# APPENDIX **A-2**

*Draft Environmental Impact Statement  
Comments and Responses*

Subject: Technical Assistance for the Draft Environmental Impact Statement for the proposed Hawaiian Memorial Park Cemetery Expansion Project, Kāne'ohe, O'ahu

## U.S. FWS - HYDROLOGY, COMMENT 2

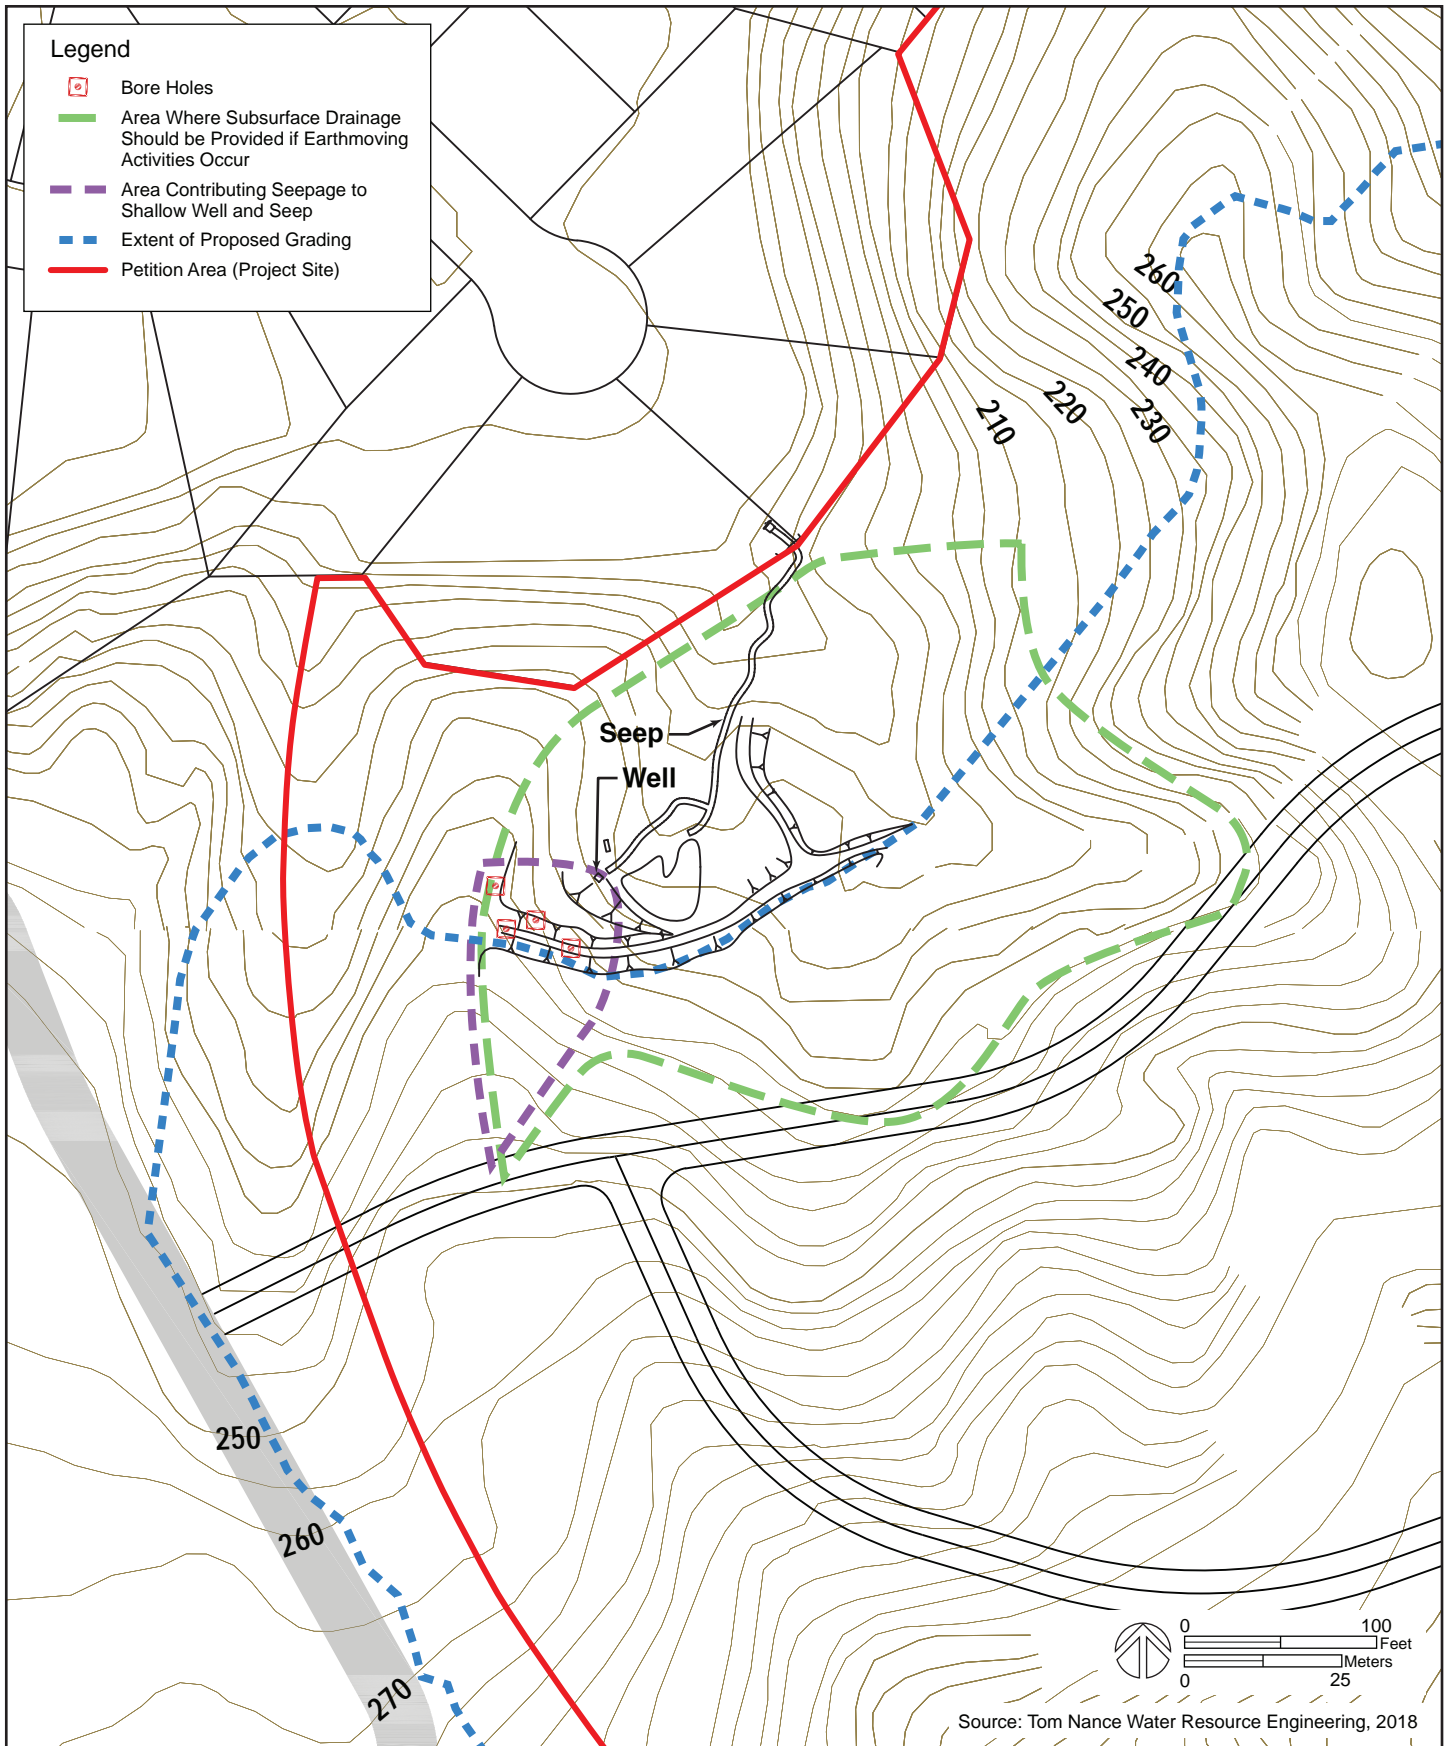
Based upon these tests, it was determined that grading improvements should not have a significant impact on the Petition Area's underlying groundwater conditions or the well and seep. The entire Petition Area overlies caldera-filling volcanics that are virtually impermeable. As such, grading improvements and cemetery use of the area do not have the potential to impact ongoing or possible future uses of groundwater drawn from the permeable Koolau volcanics of the Koolaupoko Aquifer System.

Regarding the well and seep, the footings of the retaining walls proposed as part of the project grading plan would be too shallow to intercept the subsurface water~~groundwater~~ moving downslope. The retaining walls and fill behind them would include subsurface drains (discussed in Chapter 2).

Proposed cemetery expansion improvements are expected to have a minimal impact on the quality and volume of groundwater underlying the aquifer. The project would not significantly impact the regional watershed area or the aquifer sustainable yield of 30 mgd. Some potable water would be used to irrigate the cemetery expansion area, but the wet climate of the windward district reduces the amount of irrigation required. Cemetery operational staff indicate that irrigation is rarely needed. Water used for irrigation would have a negligible effect on the aquifer system's sustainable yield. As previously discussed, existing wells within the aquifer have a total permitted use of 10.312 mgd, and total use closely matched the permitted use volume. Additional water for irrigation use for the project would have minimal change to this use, which is well below the aquifer's sustainable yield.

These improvements would also have minimal effect on the water quality of the underlying groundwater because the entire Petition Area overlies caldera-filling volcanics that are virtually impermeable. The Petition Area is located below and well away from the UIC line that generally runs mauka of Kamehameha Highway, and is thus situated above an exempt portion of the Ko'olaupoko Aquifer.

## CITY DPP - COMMENT 2b

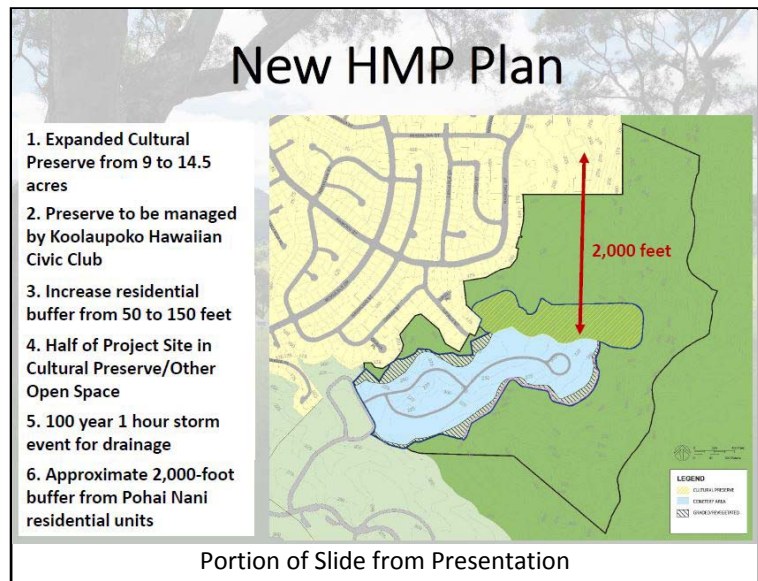
Consequently, the approximately 1,900-foot buffer distance is consistent with this guideline, which identifies a 2,000-foot buffer. Under Section 24-6.5 of the Ordinance, the City Department of Planning and Permitting (DPP) has the authority to determine whether a proposed development is consistent with the KPSCP. This decision needs to primarily take into consideration the extent to which the development is consistent with the vision, policies, and guidelines set forth in the plan. The information included in the DEIS along with these responses should provide sufficient rationale justifying this determination by DPP.

- B. Buffer area distances in the KPSCP were based upon general conceptual plans and information submitted to the City Council during the KPSCP update process. The purpose for revising initial concept plans throughout this process was to address "visual concerns" expressed by Pohai Nani residents even though private views are not protected by any State or City statutes. We understand DPP has consistently supported this position over the years. For example, an adjacent homeowner could construct a new dwelling that would block a neighbors prior views, without interference by government. The 2,000-foot buffer language was included by the Council Planning and Transportation committee based upon conceptual plans provided to the committee that stated the distance was approximate (see Response B.5 below). Throughout the process, correspondence and testimony from DPP supported the project, even with the cemetery expansion up to the Pohai Nani property line, with elimination of the housing component, and then with revised concept plans showing an approximate buffer distance. The extensive vegetation and trees that would remain within the buffer area, under the conservation easement, further provides a visual buffer from the cemetery expansion. Therefore, based upon these several factors, current project plans reflect the intent to meet the buffer guideline expressed in the SCP. Background information on the plan revisions and actions occurring during the SCP update process is provided to clarify the guideline nature of the buffer area proposed and project consistency with this guideline.

1. The original SCP amendment application for HMP filed in April 29, 2009 included a conceptual plan that had the cemetery expansion extending further east up to the Pohai Nani property line. It is noted that even with this expansion area, an August 26, 2010 letter from DPP acknowledged the application filing, and indicated an inclination to look favorably on this request because cemeteries filled an island-wide need.
